**THE APPLICATION AND CONFORMITY
OF THE
JAPANESE NUCLEAR REGULATION AUTHORITY'S
NEW SAFETY STANDARDS FOR NUCLEAR POWER PLANTS**

THE ASSESSMENT GUIDE OF VOLCANIC EFFECTS TO THE NUCLEAR POWER PLANT

Opinion and Statement of JOHN H LARGE

REVISION N ^o	APPROVED	CURRENT ISSUE DATE
			28 JANUARY 2015

53 Consider the English language version of Figure 1 of VAG, reproduced below, which purportedly mimics Figure 1 of IAEA SSG-21 (as reproduced in ¶17).

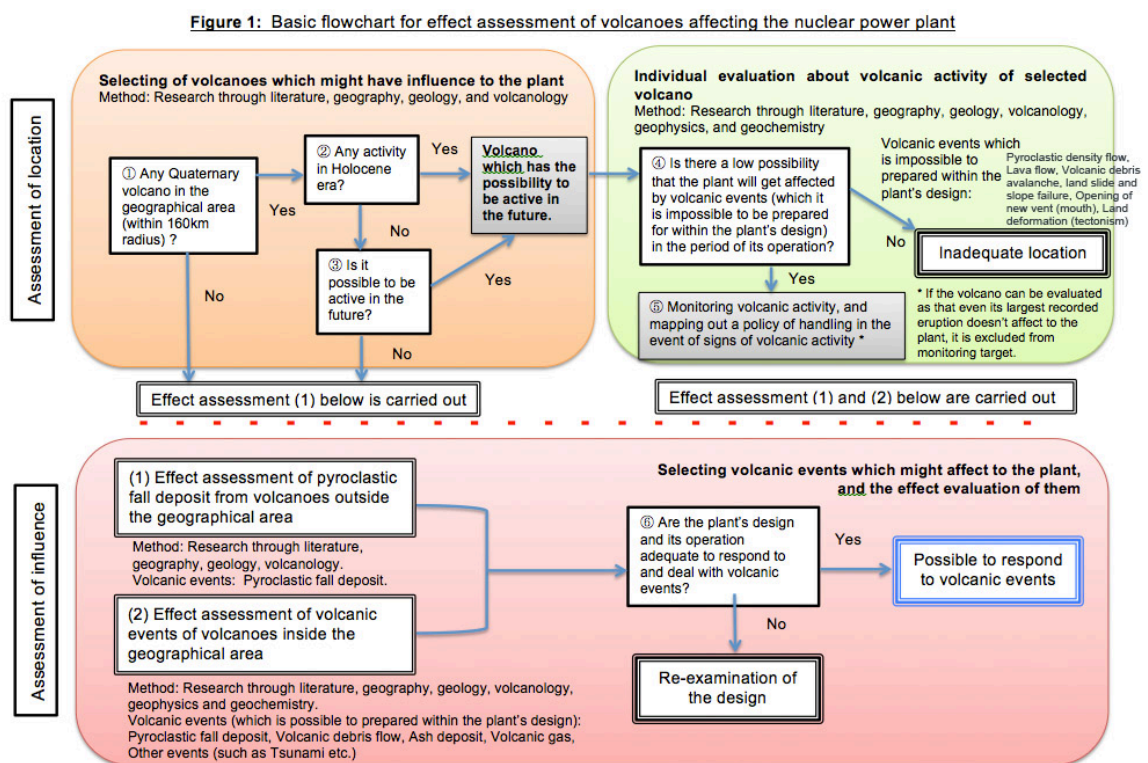
54 Under item 5 (in the right hand green box ■ above) the asterisked caveat states that

“... If the volcano can be evaluated as that even its largest recorded eruption doesn't affect to the plant, it is excluded from the monitoring target’.

55 In effect, by excluding volcanoes on the basis of the magnitude of past events alone, this runs counter to the IAEA approach that evidence of an eruption during the Holocene (last 10,000 years) is a widely accepted and reliable indicator that future eruptions are

credible, meaning that the evaluation should proceed to the next stage referred to as *Assessment of Influence* (IAEA equivalent 4th stage).

- 56 In fact, the IAEA recognizes that the geologic record, as wholly relied upon in item 5 VAG above, is usually incomplete and smaller past eruptive events may have not been preserved in the geologic record. The possible absence of some past events from the geologic record are sources of uncertainties, giving rise to aleatory variability³ that needs to be properly addressed in the NPP site volcanic hazard assessment.
